RECEIPT DATE: 5/24/23 **ONSITE SEWAGE DISPOSAL SYSTEM** P 574142

PROPERTY ADDRESS: 14005 Clarksville Pike

**SEPTIC SYSTEM
 INSTALLATION SITE PLAN
 14005 CLARKSVILLE PIKE**

From: Silvast, Zackary
Sent: Tuesday, September 26, 2023 2:38 PM
To: Luke Groom
Cc: Paul Cavanaugh; Williams, Jeffrey; Wolf, Kevin; Page, Shepsura; Bernard, Dana
Subject: regarding 14005 Clarkesville Pike OSDS plan revision comments.
Attachments: 14005 Clarkesville Pike specs (most recent).pdf

PROFESSIONAL CERTIFICATION
 I HEREBY CERTIFY THAT THESE DOCUMENTS WERE PREPARED OR APPROVED BY ME AND THAT I AM A DULY LICENSED PROFESSIONAL ENGINEER UNDER THE LAWS OF THE STATE OF MARYLAND, LICENSE NO. 20748, EXPIRATION DATE: 02/22/2023.
 Signature: Michael Vitucci
 Date: 6/30/22

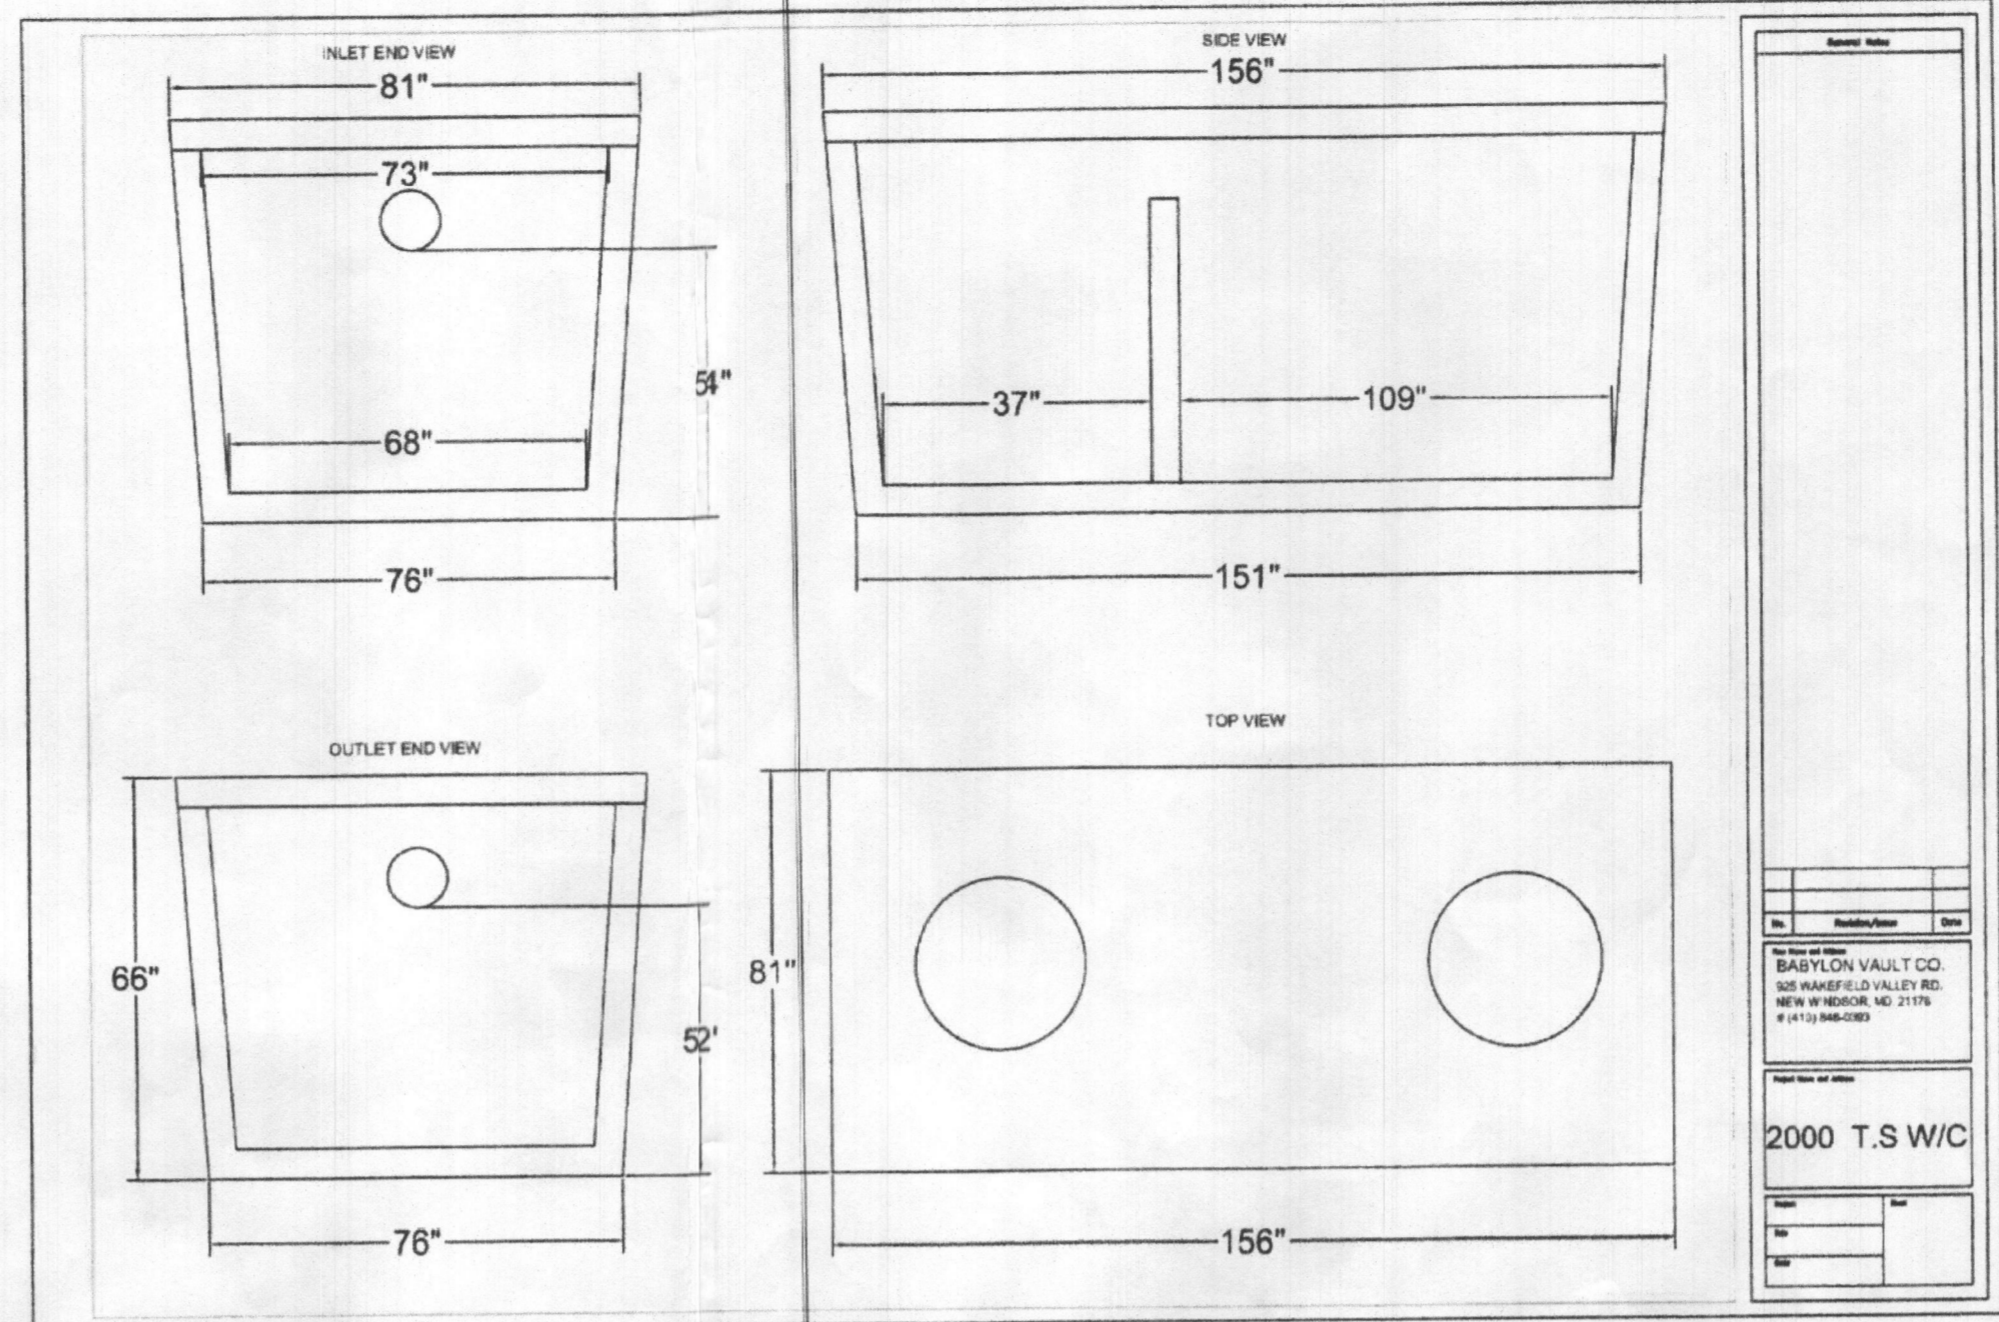
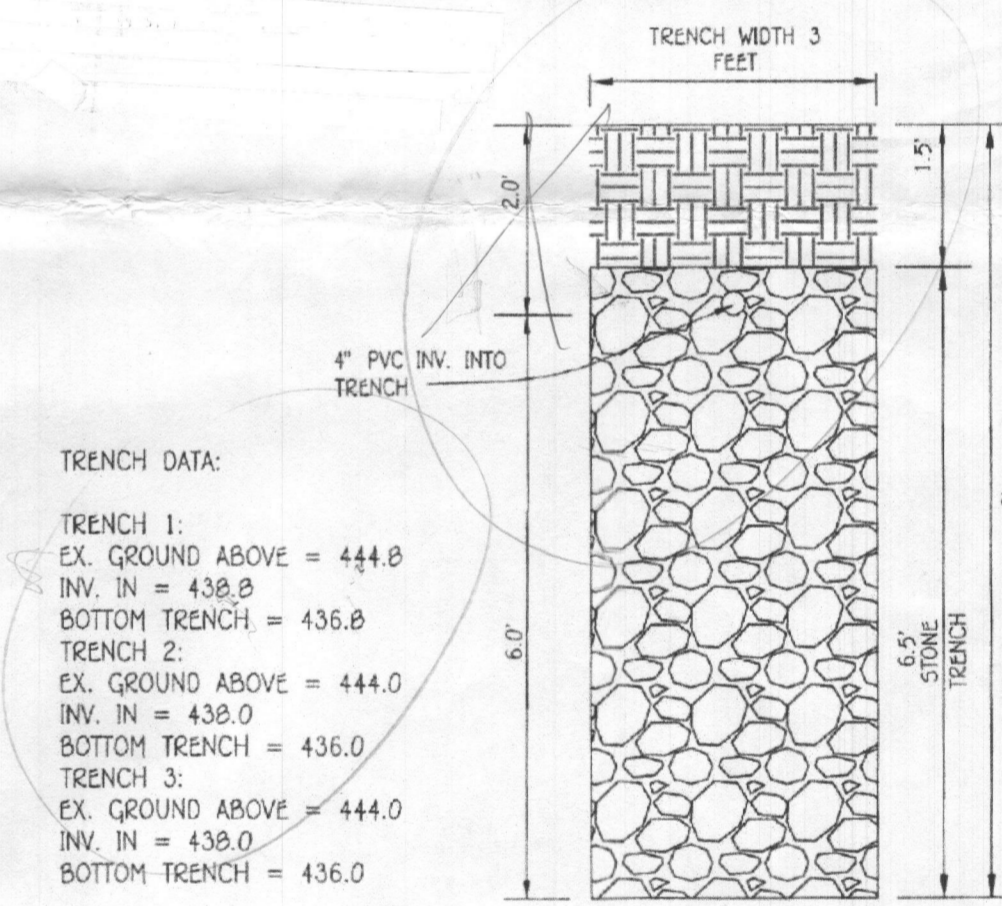
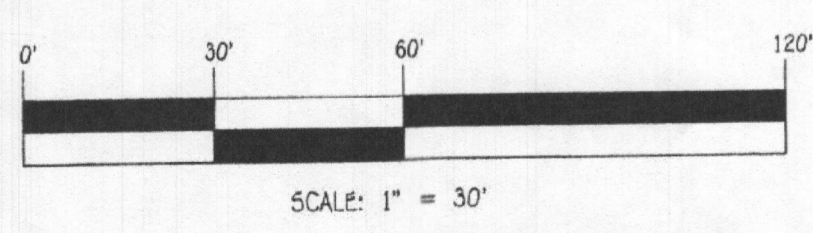
1. **This is no longer a redline submittal. We are requesting a whole new plan with three fresh copies for signature.**
2. **The septic profile detail DID NOT update all the necessary elevation changes with the tank and the invert pipe coming out of the house.**

3. **The redline grading should be flattened out further across contour line 448.**
 - a. **We do not want the tank in that large of a created depression and square in the middle of it.**

- b. **May want to slide the tank downhill closer to the SDA. (might provide better than barely one percent fall from invert)**
4. **The trench data by the initial trench detail is incorrect showing a 6' invert.**

5. **The trench detail itself is incorrect showing the invert going in at 2'.**
 - a. **We need this number deeper than the distribution box, obviously.**

6. **Both the 1st and 2nd replacement systems need to be created around a 0.8 perc rate like the initial system.**
 - a. **The most recent spec sheet was created in 2021 by Jeff Williams which specifies these rates and effective areas. (see attached)**

- b. **PLEASE DOUBLE CHECK ALL CALCULATIONS.**
